9103 Automatic Antenna Tuner - Serial Nos A1312 - A1342

Figure 1. Part of 9103 Tuner Assembly

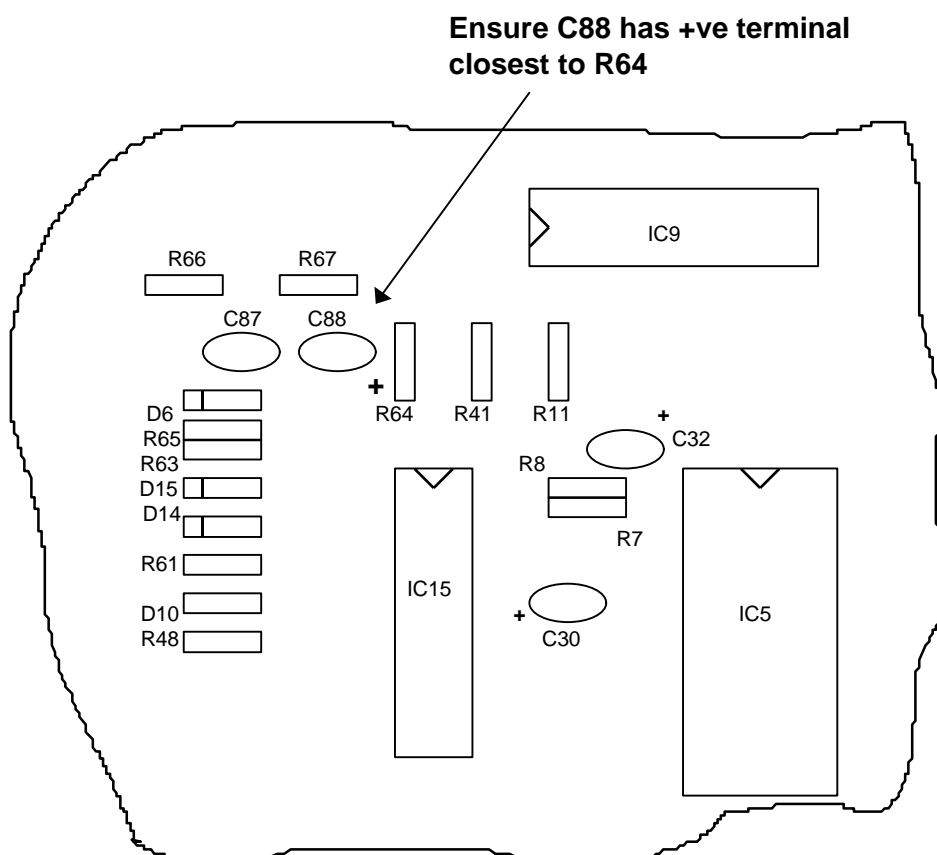
An error has been discovered on the PCB silkscreen whereby Capacitor C88 (2.2 μ F) may have been inserted incorrectly. The silkscreen identifies the +ve terminal of C88 closest to capacitor C87 and is incorrect. The +ve terminal should be located closest to Resistor R64.

On units with Serial Nos greater than A1342 the error has been rectified and the incorrect identifier on the PCB removed however, the possibility exists for some units in the Serial No. range A1312 - A1342 to have had the capacitor wrongly inserted. Whilst this may not be apparent from tuner operation, the capacitor may break down over a long period of time resulting in poor scan operation.

Owners of Tuners with Serial Nos in the above range are advised to check the orientation of capacitor C88 and replace it where incorrect. This can be accomplished by the following:

- I. Remove 10 screws securing the Tuner lid
- II. Remove 4 screws securing the shielding plate
- III. Check the orientation of Capacitor C88 as per the attached Fig 1 and if incorrect -
 - (a) Remove 4 screws securing the PCB, desolder Capacitor C88 and replace it with one correctly oriented.
 - (b) Carefully scratch off the + sign on the PCB adjacent to C88 to avoid future confusion;
 - (c) Replace the PCB
- IV. Re-assemble the Tuner
